**CITY OF OLYMPIA
DESIGN REVIEW BOARD**

**COMBINED CONCEPTUAL & DETAIL DESIGN REVIEW STAFF REPORT
June 13, 2024**

Project Name/Number:	Legion & Jefferson, 24-1901
Applicant:	Thomas Architecture Studios
Location:	411 Legion Way SE
Project Description:	5-story mixed use apartment building with 87 residential units over 1 story of retail and parking.
Zoning District:	Downtown Business (DB)
Design District:	Downtown
Comprehensive Plan Designations:	Central Business District with High Density Neighborhood Overlay
City Staff:	Casey Mauck, Assistant Planner Phone: 360.753.8048 E-mail: cmauck@ci.olympia.wa.us
Public Notification:	In accordance with OMC 18.70, notice of the application, neighborhood meeting, and Design Review Board meeting was posted on the site and mailed to adjacent property owners on April 11, 2024.

Figure 1. Southern façade of the building with areas highlighted for Board review. Staff suggests requiring brick in the red area and additional blank wall treatment in the yellow area.

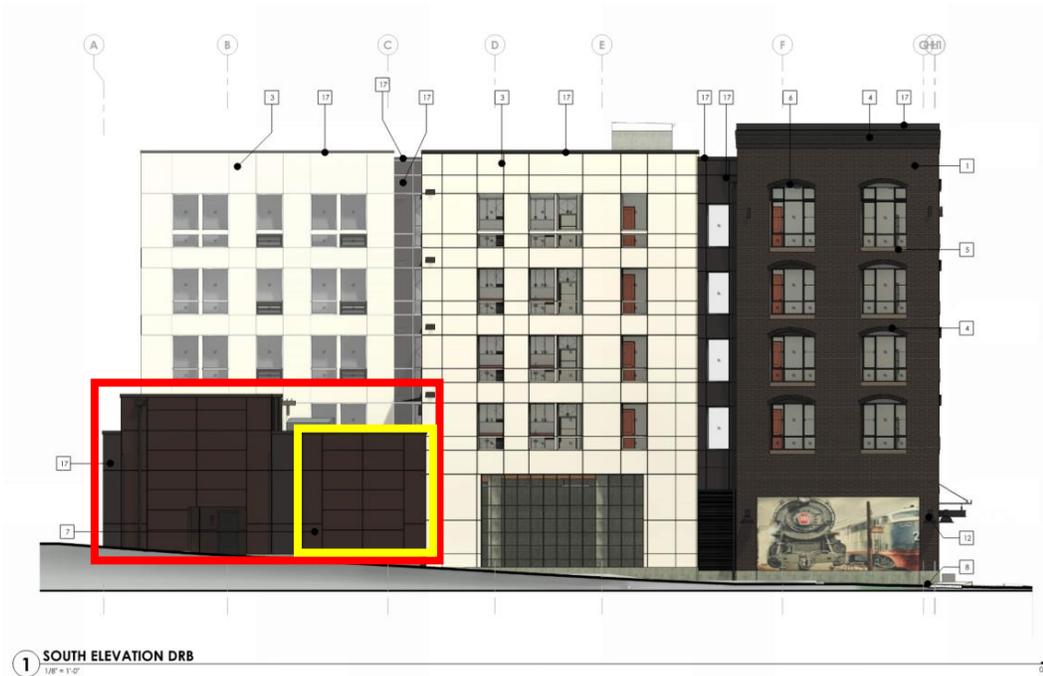
Blank walls (OMC 18.120.480.B.1): Blank walls of 400 square feet or larger, without a window, door, or building modulation or other architectural feature that face a public street, are prohibited unless treated. The southern façade includes a blank wall along the lower half of the building that is currently proposed to be surfaced with Hardieplank panels in the color “Fairfax Brown” (see yellow box in Figure 1 below). While the panels do add visual interest at a pedestrian scale, it does not use a variety of surfaces. Staff suggest requiring that part of this façade, east of the exterior door, has additional elements to treat blank walls such as a grate with irrigated vegetation or artwork. This condition could be assessed at the time of building permit by staff.

Multiple sided buildings (OMC 18.120.440.B.9): Multiple sided buildings must have consistent visual identity from all sides visible to the general public, except building walls adjacent to alleys and walls immediately abutting neighboring properties. A building must have a comparable level of quality of materials, detailing, color schemes, and fenestration on all sides visible to the general public. This requirement applies to all façades except for the west, which abuts neighboring properties. The south façade uses fiber cement siding on the western two-thirds of the building, while the other façades use brick in darker areas. Staff suggest requiring that brick is used in the area currently proposed to be Hardieplank in the color “Fairfax Brown” (see area in figure 1 below), excluding the portion covered by blank wall treatments. This condition could be assessed at the time of building permit by staff.

1. The blank wall on the southern façade, currently proposed to be Hardieplank in the color “Fairfax Brown” east of the exterior door, must include additional blank wall treatments pursuant to OMC 18.120.480.B.1 such as a grate with irrigated vegetation or artwork. This condition will be assessed at the time of building permit by staff.

2. Areas currently proposed to be Hardieplank in the color “Fairfax Brown” on the southern façade must be replaced with brick, excluding areas with additional blank wall treatment. This condition will be assessed at the time of building permit by staff.
